SAN ANTONIO PLANNING COMMISSION

PARK HILL AT THE HEIGHTS
AT S. O. PUD, POD B U-1
SUBDIVISION NAME

050309

RE: Park Hill at the Heights at Stone Oak, Pod B Unit 1, Plat # 050309
Request for variance to centerline offset of intersections.

EXHIBIT "A"

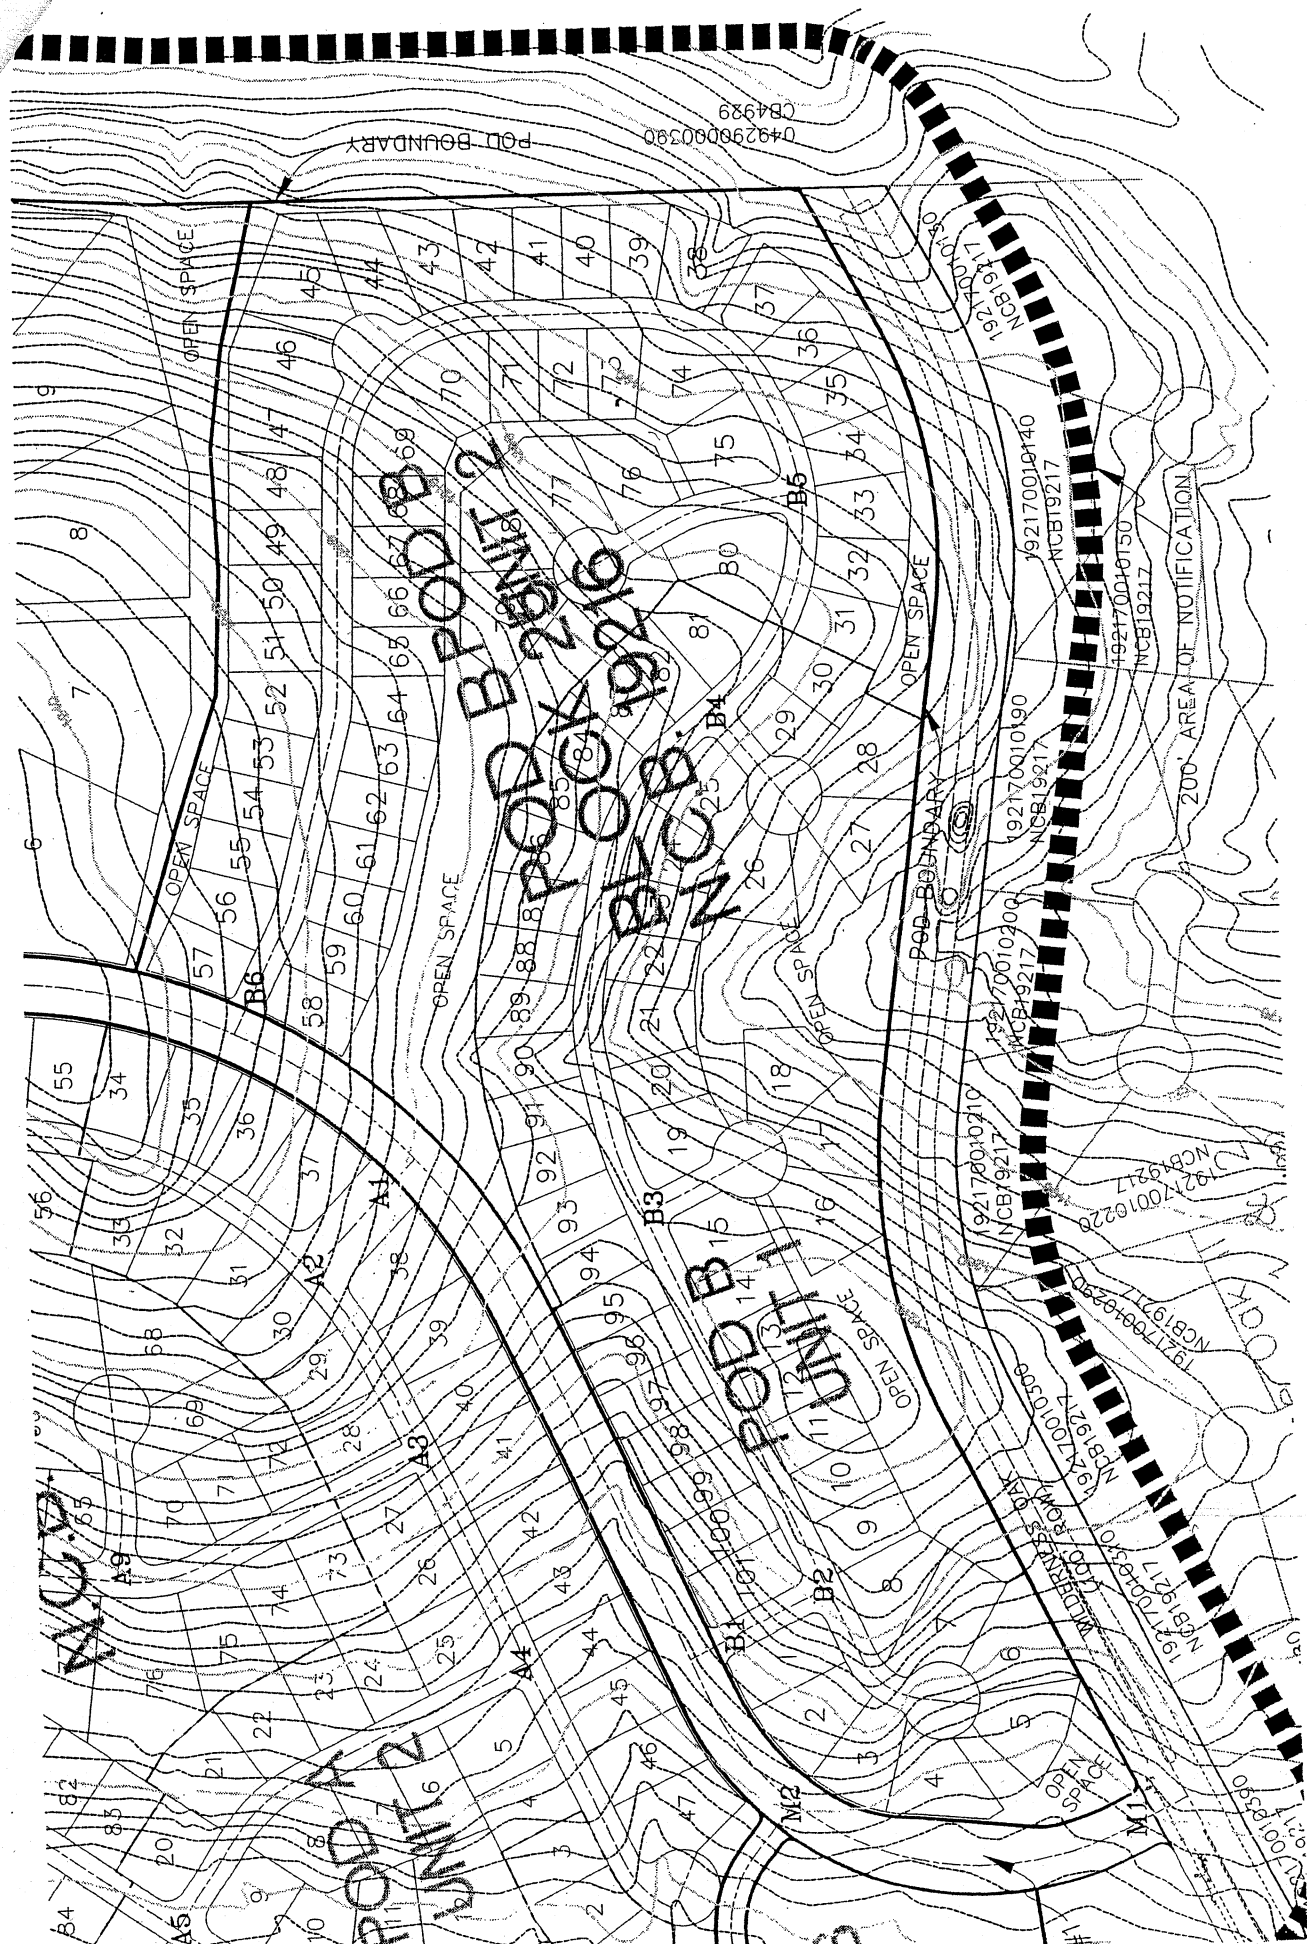
Included is a copy of the old approved P.U.D. Plan 98-027E labeled Exhibit "A" for your reference. This approved P.U.D. plan called for one major access point off of Heights Blvd. into the project at intersection B6 and a secondary/emergency access point at intersection B1. Essentially, the subdivision was one very long cul-de-sac street with a couple of minor cul-de-sacs branching off it. This plan has two major concerns. First, was the limited number of inter-subdivision street connections and second was intersection B5.

Intersection B6 is required by "UDC 35-506(f), to be at least 175 ft apart from all other intersections. The intersection of Park Hill Drive and Crescent Place to the intersection of Park Hill Drive and Evans Oak Lane as currently designed is approximately 90 ft. According to Chapter 9 of the AASHTO's – A Policy on Geometric Design of Highways and Streets this required distance is set to allow for an adequate functional area on the approach to an intersection. There are three basic elements: (1) perception-reaction distance, (2) maneuver distance, and (3) queue-storage distance that are combined together to provide for this functional area at intersection approaches.

In the case of intersection B6: (1) the perception-reaction distance is greater than 175 ft. Since there is a common area southwest of lot 79 that allows someone turning right from Evans Oak Lane onto Park Hill Drive has over 175 ft. of sight distance. Someone turning left from Evans Oak Lane onto Park Hill Drive also has more than 175 ft. of sight distance because Park Hill drive has a 80' wide right-of-way which taken with the distance between intersections B6 and Park Hill Drive and Evans Oak Lane is greater than 175 ft. (2) the intersection does not have a left-or right-turn lane, so there is not a required maneuver distance, and (3) Park Hill Dr. does not have a stop sign at the intersection with Crescent Place therefore no queue storage distance is required. We feel that the intent of the 175' spacing requirement is met.

Along the length of Park Hill Pass (the entrance street to POD B) there are two intersections located approximately 90 feet apart. The UDC requires a centerline offset between intersections of 175 feet. While intersection offsets less than the minimum normally creates safety concerns about left turn conflicts, several steps have been taken by the engineer to relieve said concerns for these two intersections. The primary turning movement at the intersection of Crescent Place and Park Hill Pass should be to the right in order to exit the subdivision. Turning movements to the left should be limited which will reduce left turn conflicts. In addition, an island has been designed between the two intersections to minimize the possibility of left turn conflicts. As indicated in the variance request letter, no stop sign exists on Park Hill Pass at Crescent Place that would create queuing problems at the intersection of Evans Oak Lane. There appears to be adequate stopping and sight distance at the two intersections for vehicles turning onto Park Hill Pass from Evans Oak Lane. Drivers stopped on Crescent Place should be able to see all approaching motorists prior to starting turns in either direction.

Since the design of the two intersections with the presence of the island should not create vehicle conflict safety concerns, DSD – Traffic Impact Analysis & Streets ***does not offer any objection*** to the approval of this variance.

EXHIBIT "B"

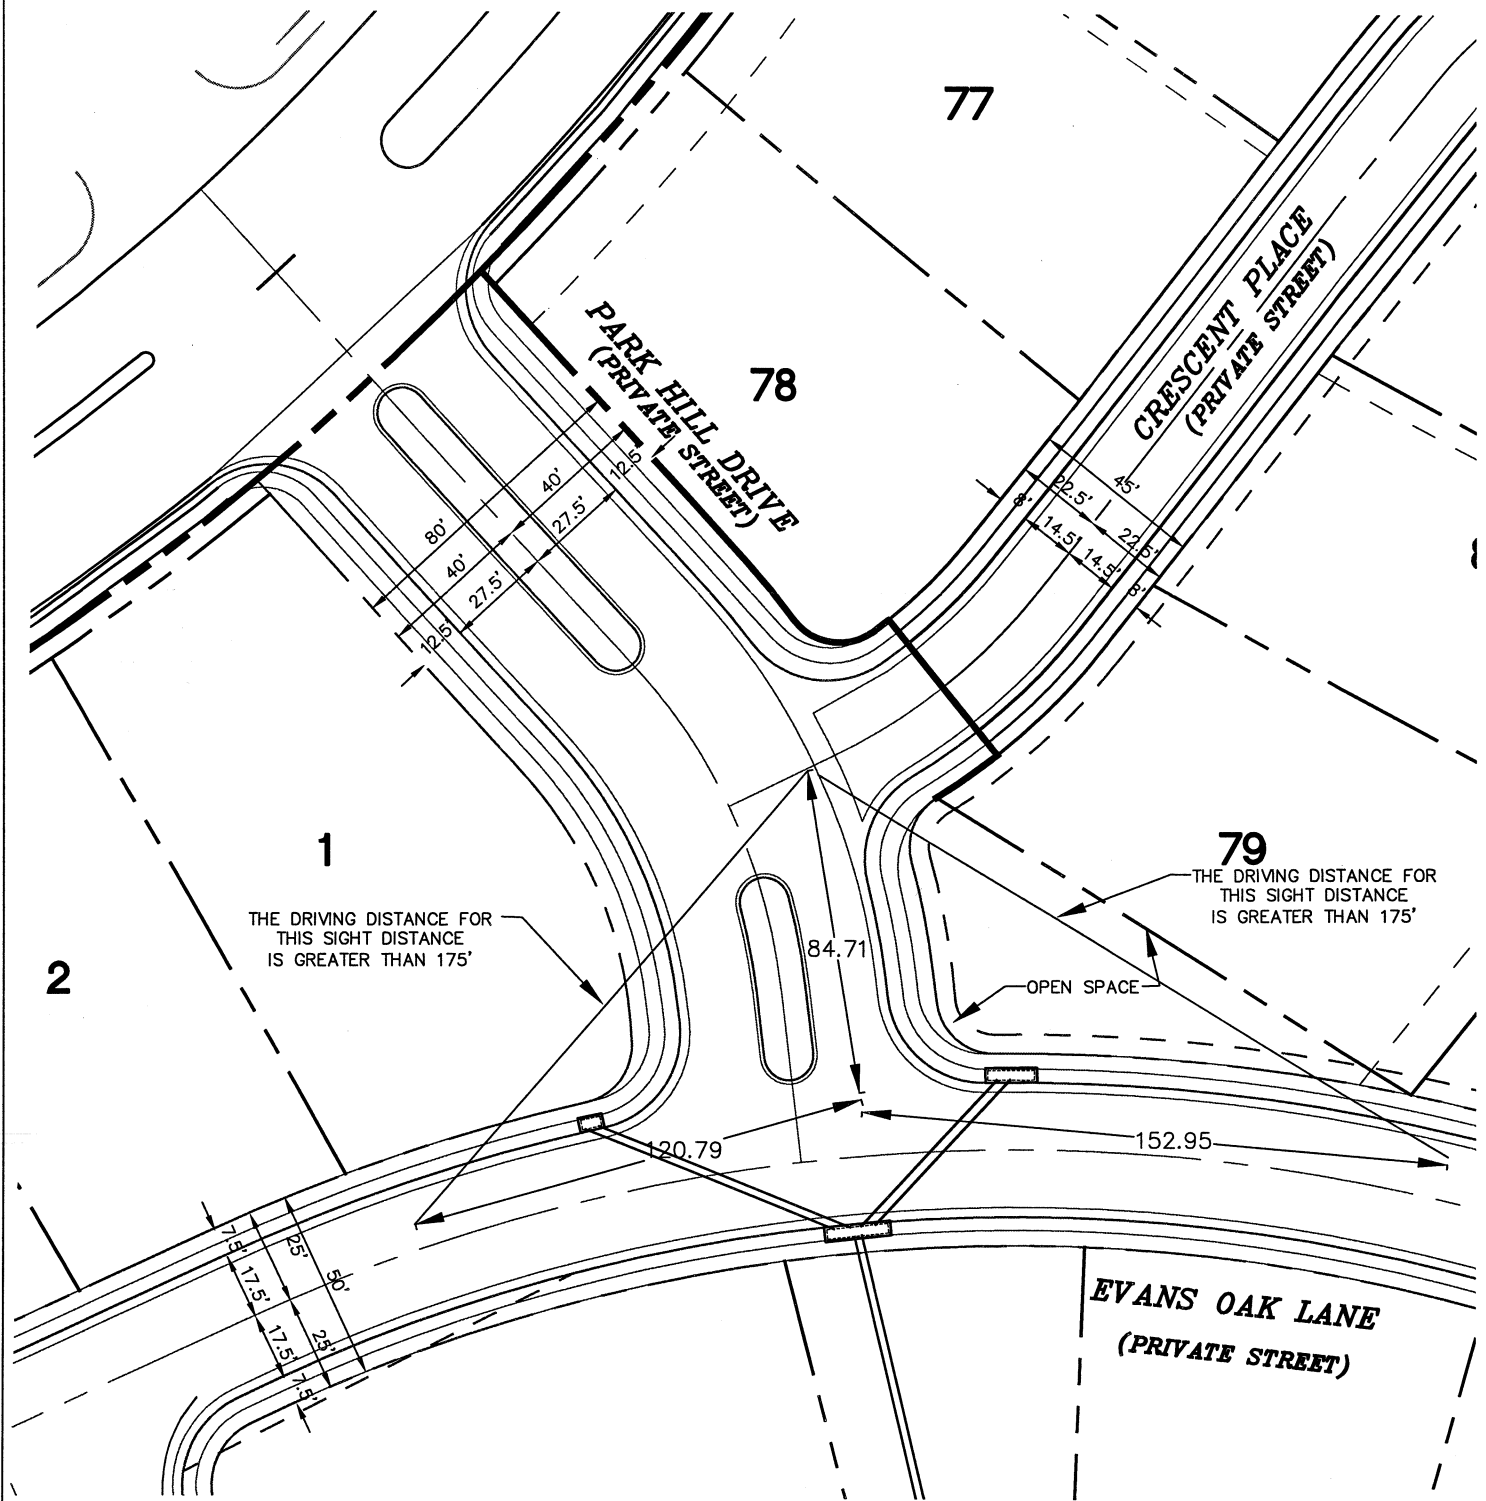
In order to create more street interconnection within the subdivision, the access point off of Heights Boulevard was moved towards the middle of Pod B frontage. (See Exhibit "B"). We also added an internal loop road, Crescent Place, to shorten the overall length of the Evans Oak Lane cul-de-sac and to disperse the traffic flow patterns. But by making these design improvements two conflicts with the Unified Development Code (UDC) are created. In reviewing the intention of the UDC code we feel confident that our design not only meets the intent of these regulations but also ensures the public safety and welfare over any other design alternative including the design that was previously approved on the old P.U.D. plan.

LOT 59 CLEAR VISION EASM.

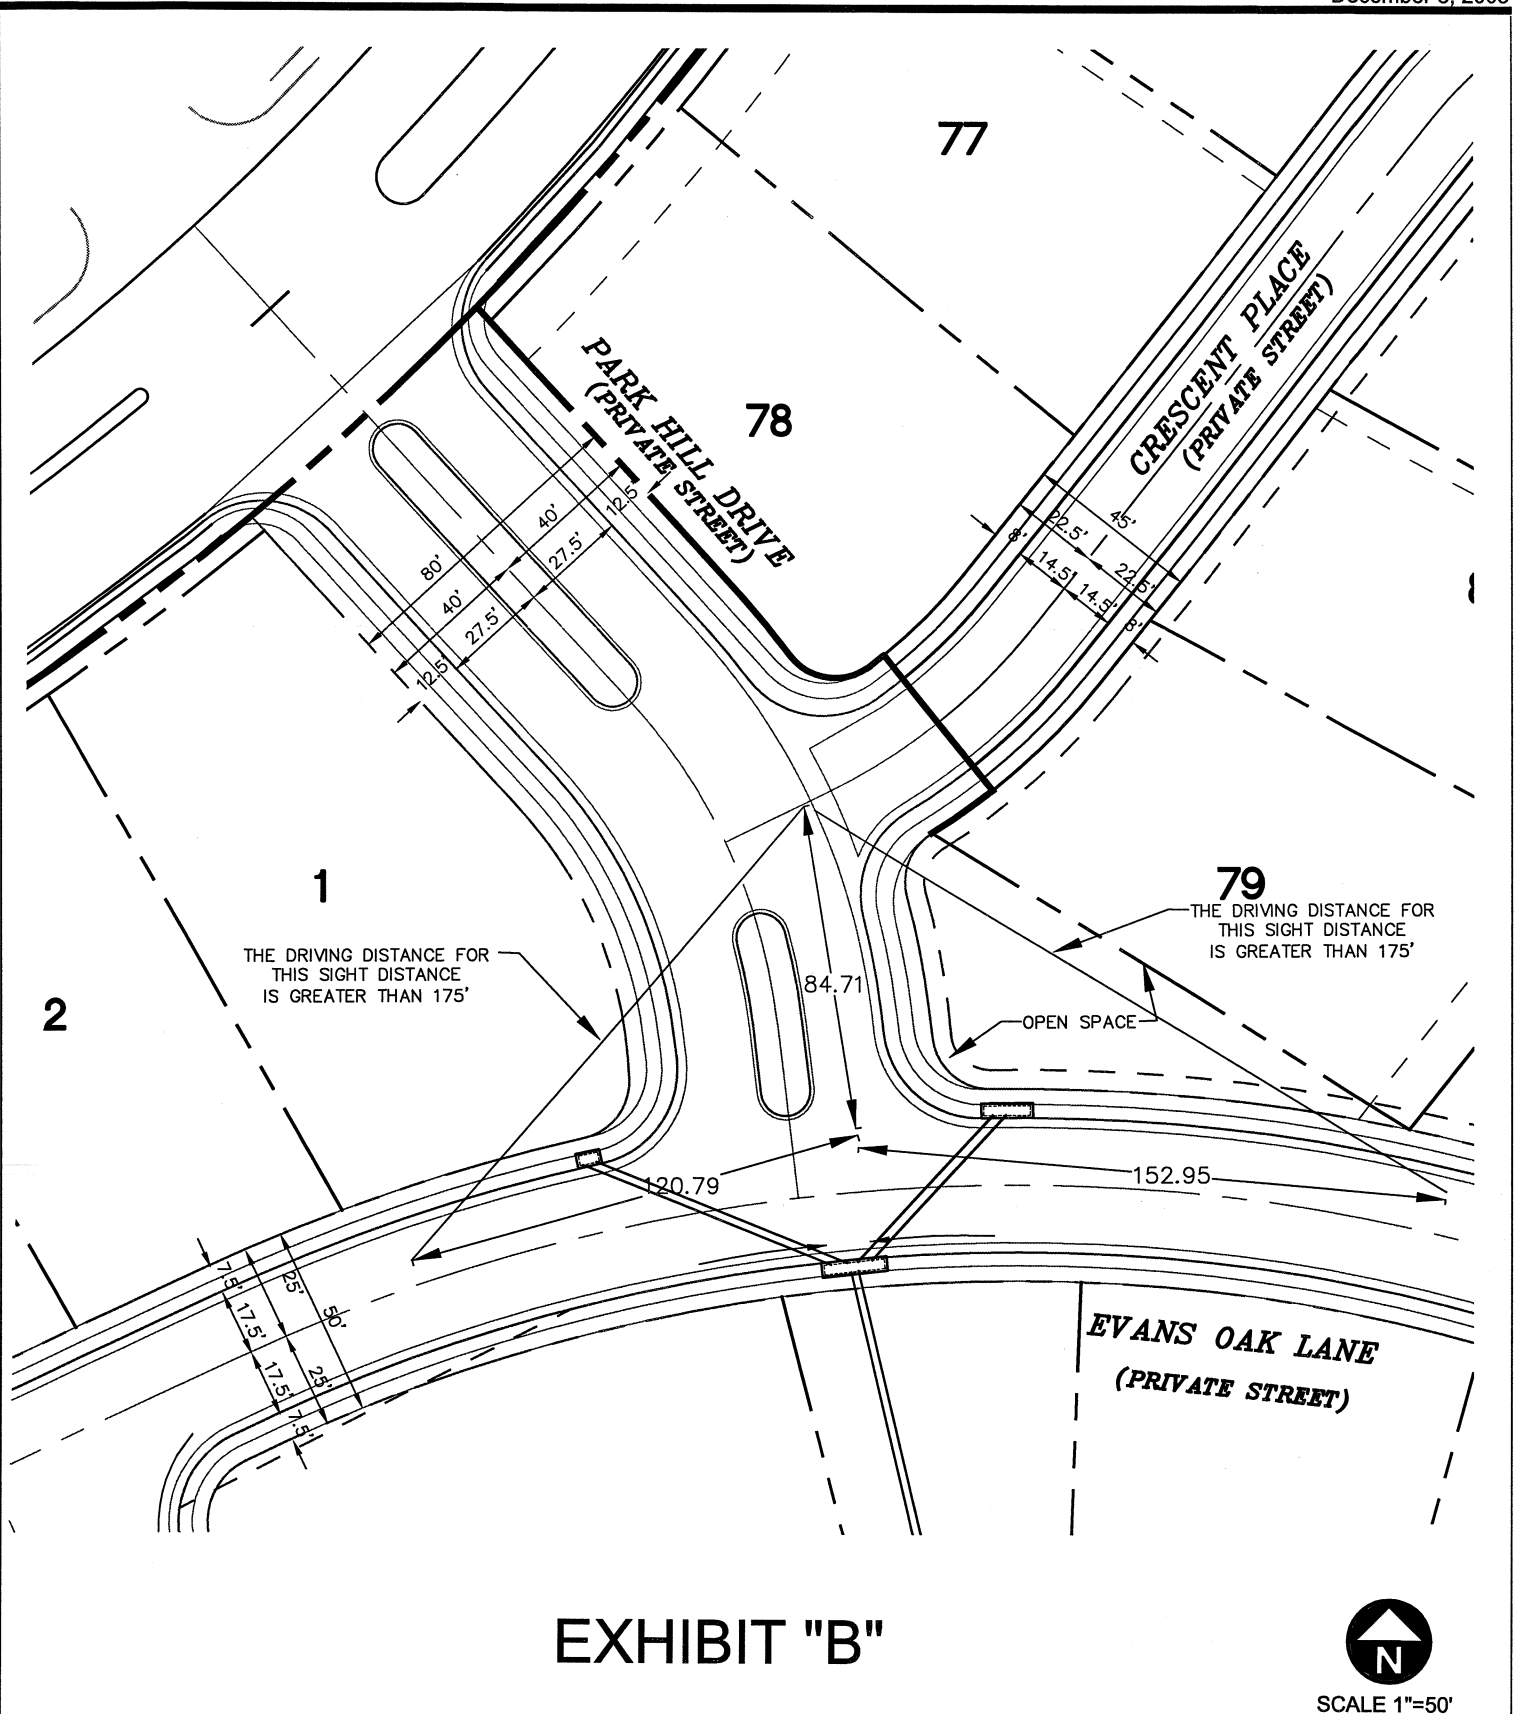
UDC 35-506(d)(5) refers to established guidelines outlined in AASHTO's - A Policy on Geometric Design of Highways and Streets to determine the length of the required intersection sight distance. Mr. Chamberlin and Mr. Friebele have decided that the design speed must be at least 30 mph and multiple control devices at the intersection (stop signs) cannot be used. The required design speed of 30 mph gives a site distance of 335' at intersection B6. As shown on Exhibit "C", this site distance requires a clear vision easement that would make it impossible to build a home on lot 59.

We are not requesting that the clear view easement to be removed completely. We are simply requesting that the hardship presented be considered and a shorter distance be required so that a home can be built on lot 59. Since Evans Oak Lane's location and elevation can not feasibly be changed, due to the sanitary sewer utilities already installed, the current intersection location is really the only one location where the intersection grades are fairly flat and disturbance to existing vegetation can be kept to a minimum.

The AASHTO guidelines for the intersection of Evans Oak Lane and Shannon Circle require that a motorist, stopped at the stop sign on Shannon Circle be able to see a minimum of 335 feet to the left and right for oncoming vehicles before turning out onto the through street. The developer's engineer has provided clear vision for more than the required 335 feet to the right and has provided clear vision for approximately 240 feet to the left. In projected low volume traffic situations, AASHTO allows for clear vision areas based upon stopping sight distance which is 200 feet for vehicles traveling 30 miles per hour. The engineer is projecting minimal traffic and the clear vision easement on the plat has an intersection sight distance of 240 feet.

Based upon the clear vision easement provided and the limited probability of traffic conflict at this intersection, DSD – Traffic Impact Analysis & Streets ***does not offer any objection*** to the approval of this variance.
